UNITED STATES PATENT AND TRADEMARK OFFICE

APPLICATION NO.	FILING DATE	FIRST NAMED INVENTOR	ATTORNEY DOCKET NO.	CONFIRMATION NO.
10/516,302	12/09/2004	Hitoshi Yoshimori	040645	5589
23850 7590 02/07/2007 ARMSTRONG, KRATZ, QUINTOS, HANSON & BROOKS, LLP 1725 K STREET, NW SUITE 1000 WASHINGTON, DC 20006			EXAMINER MAI, ANH T	
			ART UNIT	PAPER NUMBER
			2832

Office Action Summary

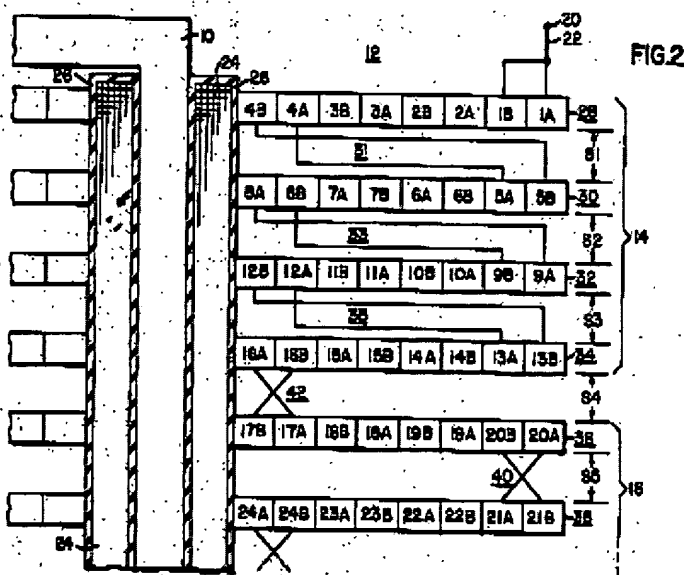
2. Claims 1-8 are rejected under 35 U.S.C. 102(b) as being anticipated by Van Nice [3705371].

Van Nice discloses an air-core coil comprising:

- unit coil portions 28, 30, 32, 34 each having at least one conductor wound into a spiral form ;
- the unit coil portions being arranged repeatedly axially of the coil;
- each of the unit coil portions comprising a plurality of unit turn portions 1A, 1B, 2A, 2B, 3A, 3B.. which are different from each other in inner peripheral length; and are direct contact with each other;

- the unit turn portions of small inner peripheral being at least partly forced inwardly of and adjacent to the unit turn portions of great inner peripheral length [coil turn 1B is smaller than coil turn 1A in peripheral length];
- the plurality of unit turn portions providing each of the unit coil portions are sequentially wound from the outer peripheral side to the inner peripheral side [from 1 to 10];
- one unit turn portion of the inner most periphery being connected to another unit turn on an innermost periphery F of the adjacent unit coil;
- whereby each of the unit coil portions is made at least partly multi-layered [see figure 2].

With respect to claims 3-4, Van Nice discloses the air-core coil fitted around a core 10 [figure 1, col 1, lines 49-69].
